Subject: **Request for Modification to Individual Section 404 and 401 permits and Neuse Riparian Buffer Authorization** for construction of the US 70 Bypass. Construction of the US 70 bypass from SR 1300 to East of SR 1556 in Wayne County. State Project No. 6.339002T. TIP No. R-2554BA. Debit \$575 from WBS 34461.1.1.

The purpose of this letter is to request modification to an U.S. Army Corps of Engineers (USACE) Section 404 Individual Permit Modification, as well as a N. C. Division of Water Quality (NCDWQ) Section 401 Water Quality Certification and Neuse Riparian Buffer Modification. In addition to the cover letter, this modification request also includes illustrations for the permit sites involved.

DETAIL
CHANNEL CHANGE
(Not to Scale)

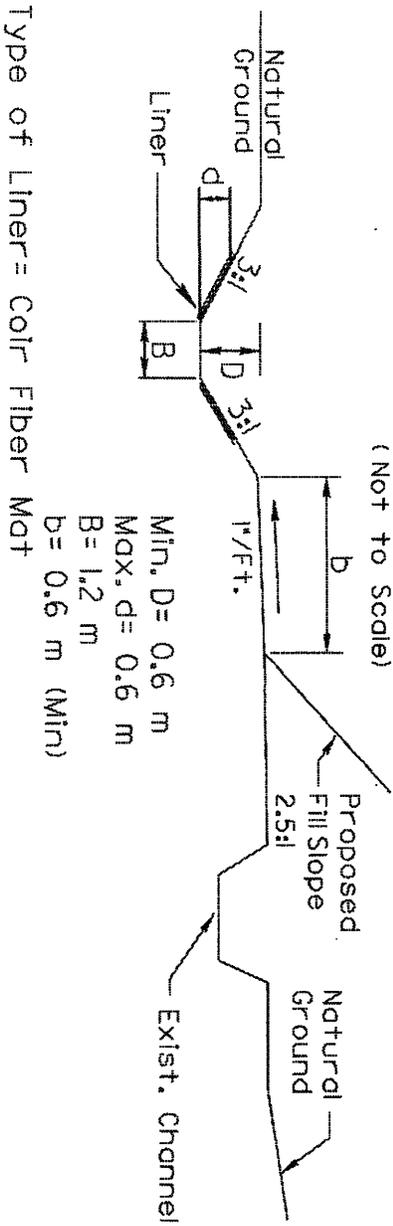
Length of new channel = 83.18 meters

Base Width of new channel = .9 – 1.2 meters

Depth of new channel = .6 meters

Streambank reforestation to include Black Willow and Silky Dogwood live stakes.

Due to existing wooded area immediately South of the new channel and embankment immediately North of the channel, no floodplain plantings will be installed.

No water will be turned into the channel until adequate vegetation develops.

Site 10 New channel length = 83.18 meters

Site 11 Existing channel length = 42.8 meters

Net Gain of channel = 40.38 meters

Type of Liner = Coir Fiber Mat

FROM STA. 139+80 TO STA. 140+63 -L- RT

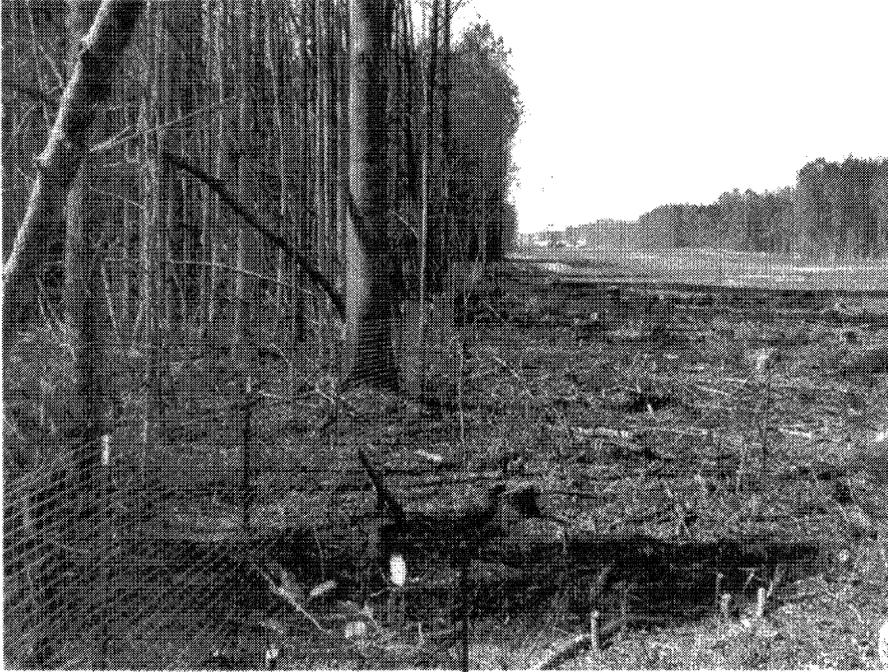
Location of mechanized clearing zone and future location of new channel (Site 10)

Existing channel that will be “short circuited” along fill of future fill slope (Site 10).
